CARKEEK TOWNHOMES

DESIGN RECOMMENDATION MEETING
SDCI #3032702-LU | 02 DECEMBER 2019

BUILDING 1 MASSING

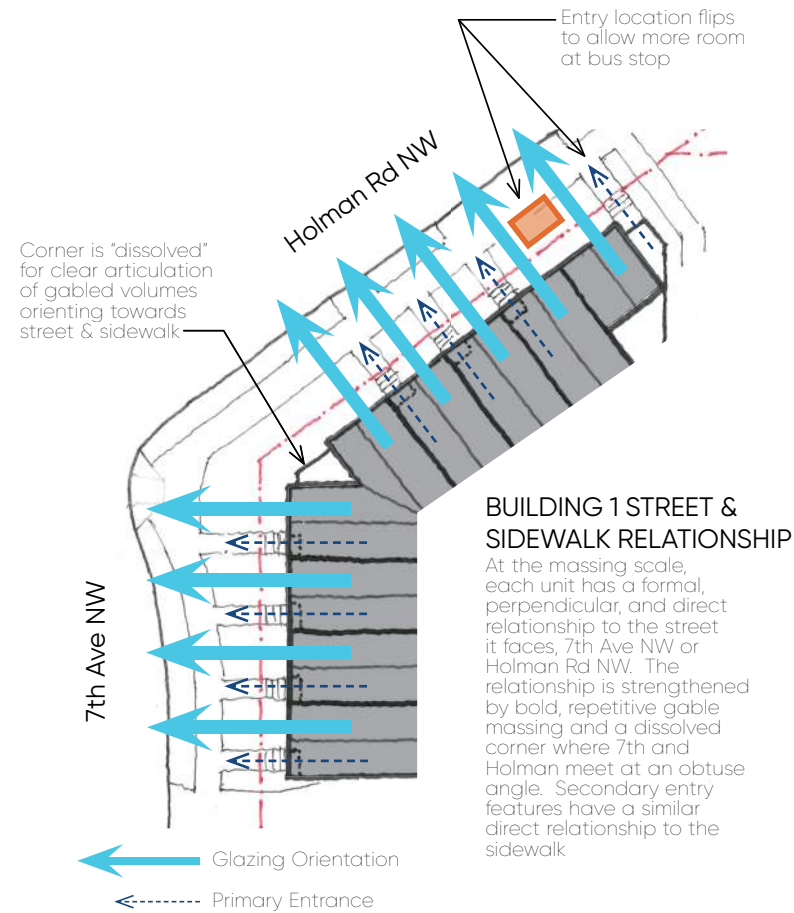
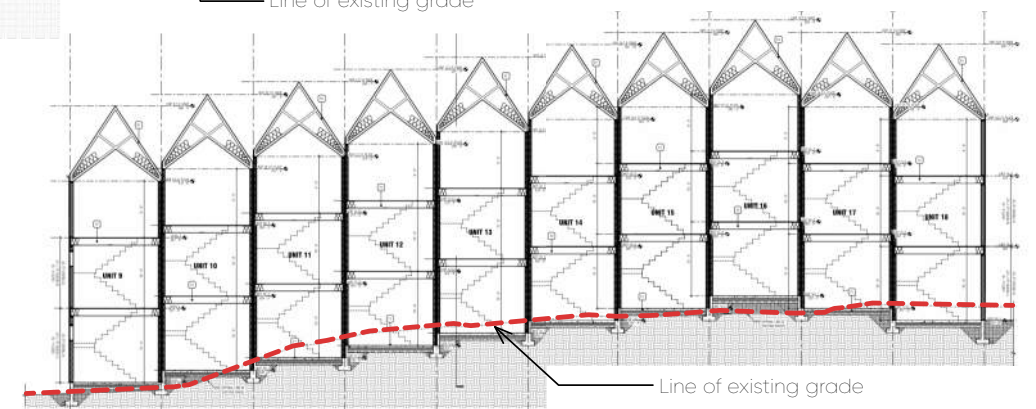
- a. The Board unanimously supported massing Option 3, the applicant’s preferred massing option, as it responds well to site topography, maximizes the connection to the public realm by locating living spaces at the street-level, and includes thoughtful pedestrian circulation on site. (CS1-C, CS2-B, PL1-B)

- b. The Board supported the clear and orderly articulation of the mass, the expression of individual units through the gabled roof form, and the design intent and precedent imagery on page 17 of the EDG Packet. The Board, however, directed further resolution of the mass at the corners along Holman Road NW in a manner consistent with the overall architectural concept. (DC2)

- c. The Board was concerned that Unit 1C complicated the building form and recommended further development in a manner that provides relief to the pedestrian pathway and bus stop. (PL1-B, DC2)

- d. The Board supported horizontal modulation expressed in the precedent imagery and noted that massing Option 3 appears to be developing in the right direction. The Board specifically prioritized Design Guideline DC2-B, Architectural and Façade Composition. (DC2, DC2-B)

- e. The Board supported the move to shift the bulk of the mass away from the single family zone, as shown in massing Option 3. The Board specifically prioritized Design Guidelines CS2-D, Height, Bulk, and Scale, and DC2-A, Massing. (CS2-D, DC2-A)

- f. The Board noted that massing Option 1 has a similar frontage along 6th Ave NW and works without a departure from upper-level setback requirements. The Board questioned whether the requested departure for massing Option 3 was appropriate along the single family zone transition. The Board was not inclined to support the requested departure without further study and a stronger design rationale. Demonstrate that all alternative solutions have been explored. (CS2-D, DC2-A)

- g. The Board specifically prioritized Design Guidelines CS1-B, Sunlight and Natural Ventilation, and CS1-C, Topography. The Board noted detailed sections will be critical to understanding the response to topography, and requested they be provided at the Recommendation phase. (CS1-B, CS1-C)

- h. The Board supported the location of active living spaces at the ground-level along the street frontage. The Board specifically prioritized Design Guidelines CS2-B, Adjacent Sites, Streets, and Open Spaces, and DC2-E-1, Legibility and Flexibility. (CS2-B, DC2-E-1)

The overall massing and architectural concept addresses a variety of site conditions on an unusually shaped lot. Street facing entries are maximized where street frontage is available at buildings 1 & 3. In the center of the site, away from streets, solar orientation is maximized and dwelling units trace the site’s topography in a graceful cascade at building 2. Simple gable roofs define individual dwelling units with a distinctly domestic character and break down the overall mass of each building. The gables, in association with the glazing composition, provide the structures a pleasing rhythmic quality. Building facades are then textured with secondary architectural details like generous glazing, bays or recesses, decks, and canopies over raised entries with robust landscaping.

Building 1 is defined by occupying the obtuse angle created at the intersection of 7th Ave NW and Holman Rd. Maintaining the repetitive gable roof articulation through this geometry presents a unique challenge. In order to maintain a consistent module across both Holman Rd and 7th Ave, the corner is “dissolved” to provide a buffer between the two sets of gabled roof masses. Reducing the presence of the corner is accomplished by stepping back, holding the roof down a story, and cladding is a contrasting accent material.

Building 2 occupies a portion of the site with the most topographic change; from west to east across the building, existing grade rises about 12’. The proposed design uses this grade change to terrace individual dwelling units and smooth the existing slope into even 1’-9” steps. The terracing is accentuated through the use of stepping bioplanters, thoughtfully placed site stairs and coordinated lighting. The result is an elegant cascade experienced along a common pedestrian path connecting east and west sides of the development.

NE corner held down, recessed, and clad in contrasting accent material. The resulting shape allows the 13' gable module to terminate cleanly. Also moves the entry of unit 8 away from the bus shelter

"Knuckle" held down as an open deck at 3rd floor level and clad in contrasting accent material. The resulting shape allows the rhythm of gables to read clearly on both Holman Rd and 7th Ave

SITE PLAN W/ TRANSIT ACCESS WALK AND BUS SHELTER

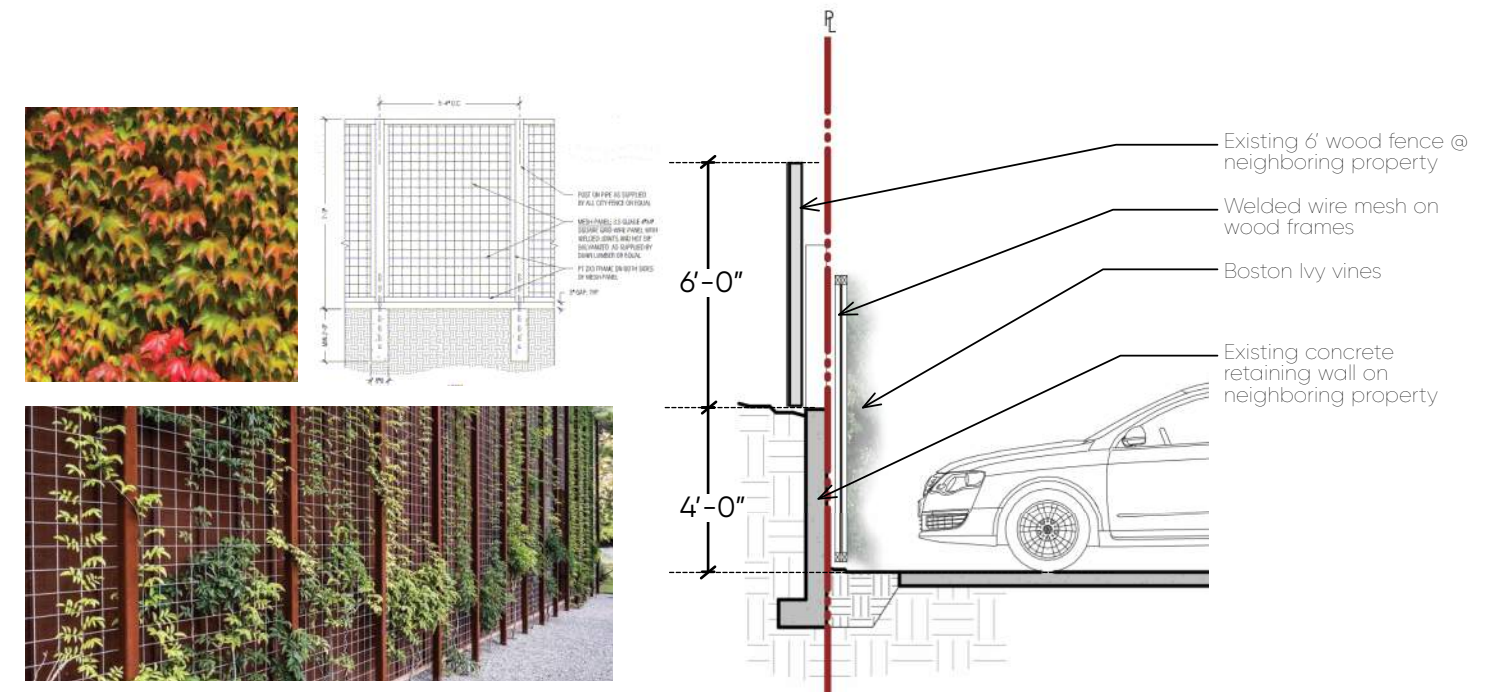
- b. The Board requested more information on the various individual entry experiences and site accessibility, including perspectives and sections. Particularly, at Building 2. The Board specifically prioritized Design Guideline PL3-A, Entries. (PL3-A)

- c. The Board questioned the response to the bus stop on Holman Rd NW and was concerned about impacts to the privacy of future residents. The Board requested more information regarding how the mass and entries are thoughtfully designed in response this concern. The Board specifically prioritized Design Guidelines PL4-C, Planning Ahead for Transit, and PL3-B, Residential Edges. (PL4-C, PL3-B)

- d. The Board appreciated the massing gap and pedestrian pathway between Building 1 and Building 2, but noted the pathway felt pinched. The pathway should be well designed and the relationship to the adjacent structures should be thoughtfully considered. The Board specifically prioritized Design Guideline PL1-B, Walkways and Connections. (PL1-B, DC2-A-1)

- e. In response to public comment, the Board was hesitant to support the departure request from landscape buffer requirements without additional information. The Board noted that light impacts on adjacent sites are partially mitigated by topography, but landscaping is also important in this location to improve the experience for future residents of the proposed development. The Board requested more information on how the reduced buffer would be designed and documentation of all alternative solutions explored. (CS2-D-2, DC4-D)

- f. In response to public comment, the Board noted that the site should be well lit for safety and security, while minimizing lighting impacts on adjacent sites. The Board specifically prioritized Design Guidelines PL2-B, Safety and Security, and DC4-C, Lighting. (PL2-B, DC4-C)

In designing pedestrian access through the site, a legible hierarchy of pathways exist. Primary routes from common parking areas traverse through landscaped common space to the perimeter of the site and the neighborhood beyond. These primary routes connect common features like parking, trash enclosures and common amenity area. Secondary paths connect the primary routes to individual unit entries through privately owned transitional spaces that act as a threshold between public and private. See Pages 41 & 42 for a more detailed description of individual unit entries.

Presenting a coherent massing strategy and thoughtful facade design facing Holman Rd and 7th Ave NW are paramount to the project. Incorporating the awkward angle created by the intersection into the building mass increases the challenge. Accordingly, the proposed design strikes a balance between providing a legible building form while still accommodating the existing bus shelter on Holman Rd. Subtle moves are employed like splitting the unit entries about the bus shelter, the placement of unit 8's stair as a buffer, and planting carefully layered green screening between the building and shelter. This way, the project recognizes the bus shelter's presence while maintaining a composed and orderly facade.

Circulating through the pedestrian pathway between buildings 1 & 2, while somewhat narrow in width, is greatly enhanced through a series of design moves. Most importantly, the walls are clad in a high quality, durable siding material that can be appreciated at close range and will not deteriorate over time. This siding also serves as a backdrop for planting of different types and heights. On the east, Japanese Hydrangea vines climb the walls to provide a strong vertical presence with out taking up too much space. On the west, a deeper planting bed is occupied by three small columnar trees with a base of shrubs and groundcover.

Regarding the departure request to reduce the landscape buffer along the east side of the surface parking lot, additional landscaping is proposed to enhance this area. The existing concrete retaining wall and cedar fence on the neighbor's property provide a 10' opaque backdrop. In front of which, wire mesh panels are proposed that will allow Boston Ivy vines to climb and eventually provide an attractive green screen with seasonal color change.

See landscape lighting plan on page 45 for further description of how the landscape lighting is tailored to site circulation and different uses around the project. The landscape lighting reinforces terracing at building 2, functionally illuminates trash area, provides security in surface parking lots, and screened to comply with 23.47A.022 - Light and glare standards

WEST TRASH AREA - SECTION @ SOUTH PROPERTY LINE

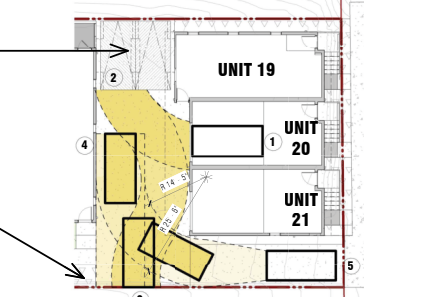
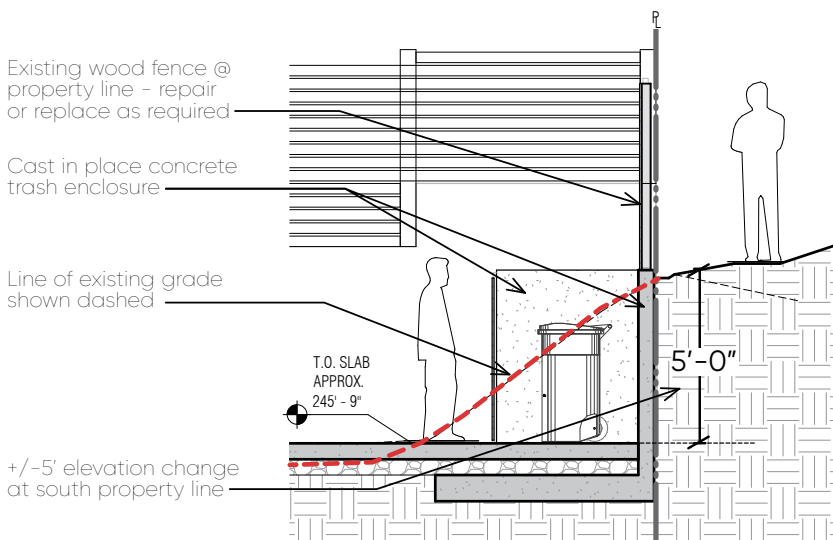
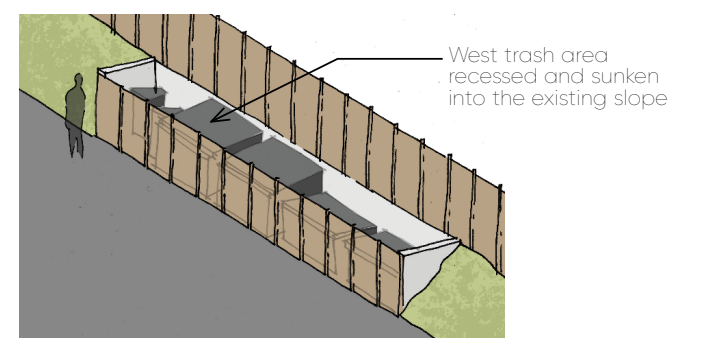
- a. The Board specifically prioritized Design Guideline DC1-C, Parking and Service Uses.(DC1-C)
- b. The Board was concerned about the vast surface parking area and noted this area should be attractively designed with a special paving treatment to create a usable, common amenity. The Board supported the design intent and pervious surface treatment depicted in the precedent image on page 17 of the EDG Packet. Support for the requested departures from parking space and screening requirements is dependent on the resolution of this guidance. (DC1-C, DC3-B, DC3-C-2)

- d. The Board noted that the departure from parking space requirements results in reduced pavement onsite and allows for street-level living spaces to connect to the public realm; however, they were hesitant to support the request as proposed without additional information. The Board requested detailed turning studies and more information on the facades facing the east parking area. (DC1-C, DC3-B)

- e. In response to public comment, the Board did not support the proposed location of the east trash storage area along the south property line and directed the applicant to explore alternative locations that minimize visual and odor impacts on the adjacent single family zone. (CS2-D-3, DC1-C-4)

- f. In response to public comment, the Board requested more information on screening and security of the west trash storage area, including a section that depicts how the storage area will fit with site topography and relate to the adjacent site. (CS2-D-3, DC1-C-4)

In response to the Board's concern over the surface parking lot, a series of site design features are offered as improvements to this area. The proposed paving is scored concrete, stained in a two tone fashion, differentiating between parking spaces and maneuvering area. The maneuvering area is scored with a greater density to break down the scale of this area. At the east property line, a green screen of Boston Ivy vines are proposed on wire mesh panels. The seasonal color change of the ivy will provide a dynamic backdrop to the parking lot. The north portion of the parking lot is defined by two larger Frontier Elm trees to further enhance the vegetated edges of the lot.

The eastern trash storage area has been eliminated and favor of enlarging the western trash storage area. Consolidating all trash at the western trash storage area places it in a location where the impacts are more easily mitigated. The western trash storage area is located at an elevation 4'-5' below the adjacent property to the south, all but eliminating the view of this area from the neighbor's property. Presence of the trash is further screened by a wooden property line fence on top of the cast concrete trash enclosure.

Eliminating the eastern trash storage area loosens up the vehicular maneuvering between buildings 2 and 3, allowing easier turning in and out of the two garage and two surface parking spaces. The surface parking spaces have also been shifted north providing additional automobile maneuvering area and easing access to the garage of unit 20. At the east façade of building 2 – facing the vehicular maneuvering area – the first floor window sills are held 5' above the level of the driveway to prevent automobile headlights from shining directly into the dwelling unit. See additional discussion of this topic on page 50 for Departure Request #3.
